# **NorthLake Specific Plan Project**

## **Final Supplemental Environmental Impact Report**

**Northlake Specific Plan Project**  
**County Project No. R2015-00408-(5)**  
**Vesting Tentative Tract Map No. TR073336**  
**Conditional Use Permit No. 201500019**  
**Environmental Review No. 201500030**  
**State Clearinghouse No. 2015031080**

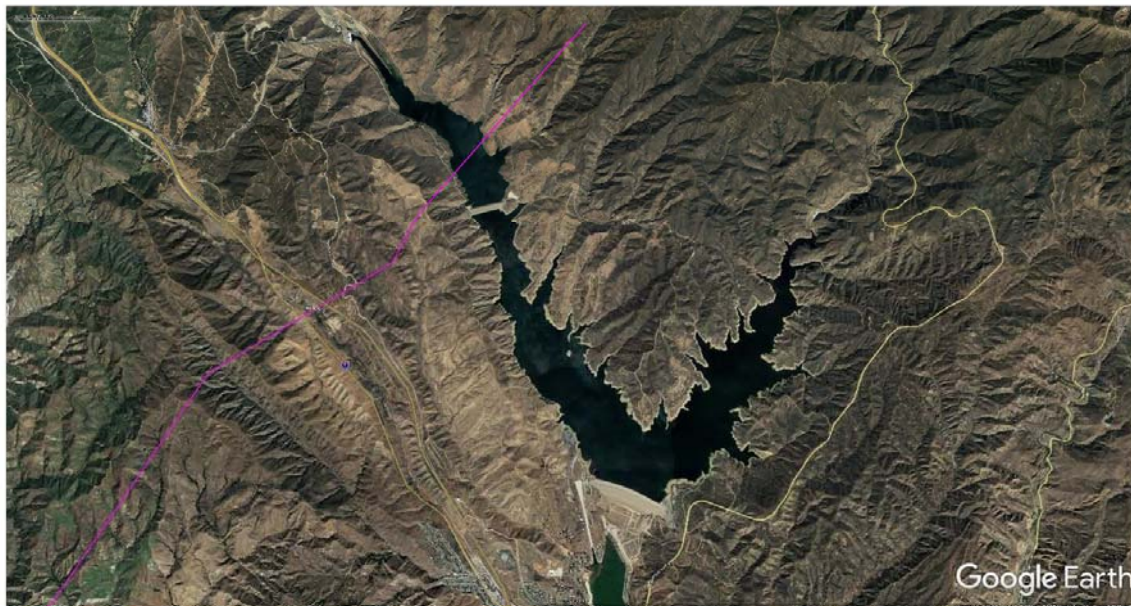
The SEIR (2017:5.2-24) concludes that there is no suitable foraging habitat available on the project site for bald eagle. This is not true. I have watched bald eagles for years foraging for ground squirrels and carrion on the annual grasslands of the Altamont Pass,

an environment very similar to proposed project site. I have also seen bald eagles taking prey items from hawks such as ferruginous hawk. Only two weeks ago I photographed two bald eagles foraging far from lacustrine or riverine habitat, and one was eating from food it held in one foot while kiting over a ridge covered by annual grassland. If those who prepared the SEIR believe that bald eagles only eat fish, they are wrong. There is no reason why bald eagles would not forage over the project area. According to eBird, bald eagles have been reported in the project vicinity.

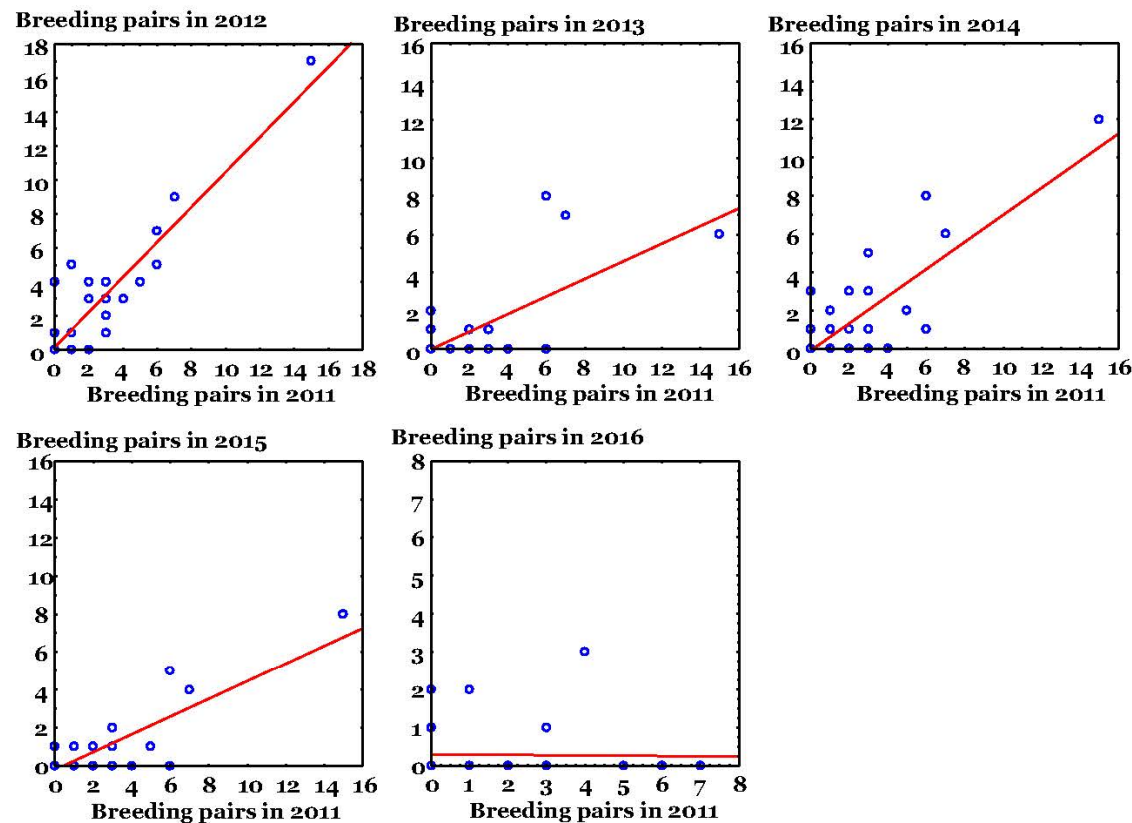
The SEIR (2017:5.2-24) reports merlin as having been observed on site, and accurately reports that the species does not normally nest in the area. It would be informative, however, to note that merlin are migratory and that the project area is within the species' wintering range. The wintering range is just as critical to this species persistence as is the nesting habitat, as no species can successfully breed without having

survived the non-breeding season. The project area is important to merlin regardless of the species not nesting there.

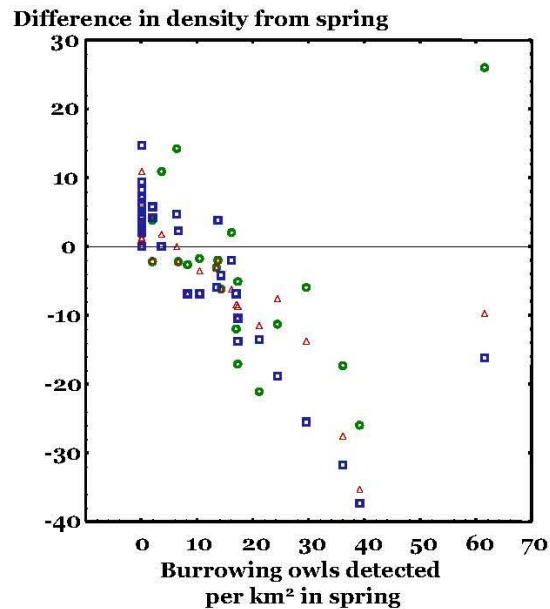
BonTerra Psomas also demonstrated lack of experience with winter burrowing owl surveys by relying on sign at the burrows, such as pellets and whitewash and prey items. These types of sign are useful for finding nest burrows, but not as useful for finding winter refuge burrows. Many winter refuge burrows are used too briefly for sign to accumulate, as wintering owls tend to move around. Also, there is little connection between breeding and non-breeding distributions, as I have found in two large study areas, including in the Altamont Pass (Figure 3). Burrowing owls generally depart from breeding areas to winter somewhere else, but not necessarily very far from breeding areas.

Further demonstrating lack of familiarity with burrowing owl surveys was BonTerra Psomas's (2015, Attachment F:5) reference to satellite burrows in the context of winter surveys. Satellite burrows are meaningful only during the breeding season; there is no such thing as a satellite burrow in winter.
